## ***Interactive comment on “Separating the effects of changes in land cover and climate: a hydro-meteorological analysis of the past 60 yr in Saxony, Germany” by M. Renner et al.***

Received and published: 10 October 2013

**Fig. 1.** Potential evapotranspiration time series for all basins and the all station decadal mean.

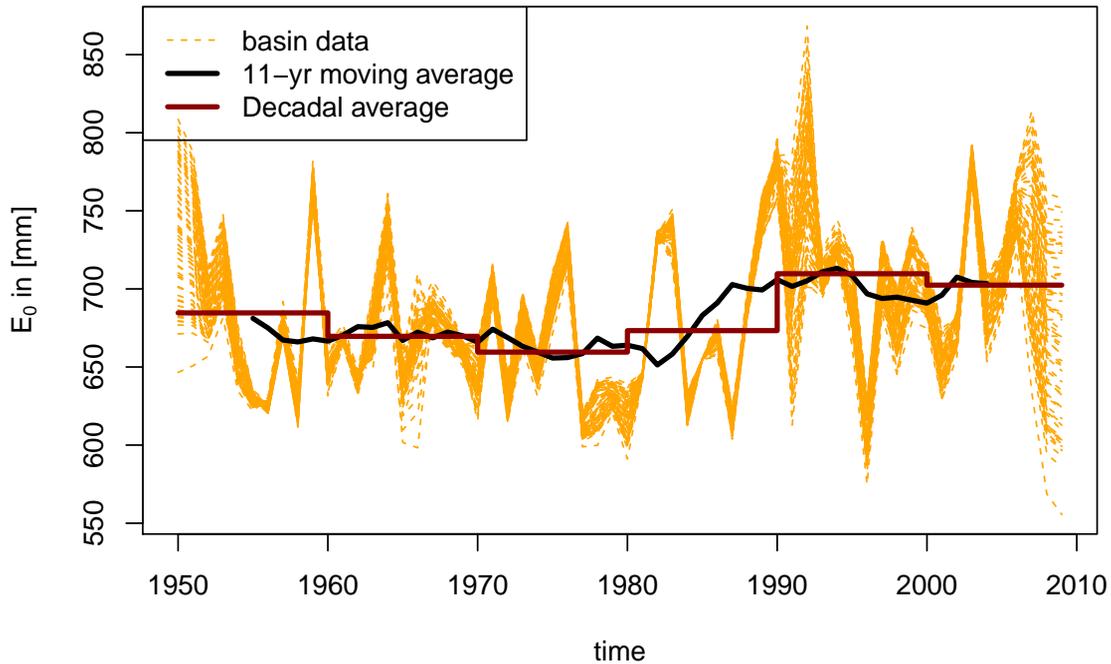
- **Line 20. Pg. 8557. I do not agree with the authors when they write the statement that there has been a significant reduction in potential evapotranspiration from 1950-1980.** In figure 4 of the manuscript we show time series of  $E_0$  and  $P$  and the non-stationary trend reversal of  $E_0$  is maybe not visible due to the small range in the y-axis. Therefore, we added Fig.1 to this reply which shows the time series for all basins and the decadal means. Additionally the argument of significant reduction of potential evapotranspiration with strongest effects in the 1980s is based on a stationarity test using the simple CUSUM test procedure. This test is based on the cumulative sum of standardized residuals of the mean. The test statistic is defined by a stationary Brownian motion process
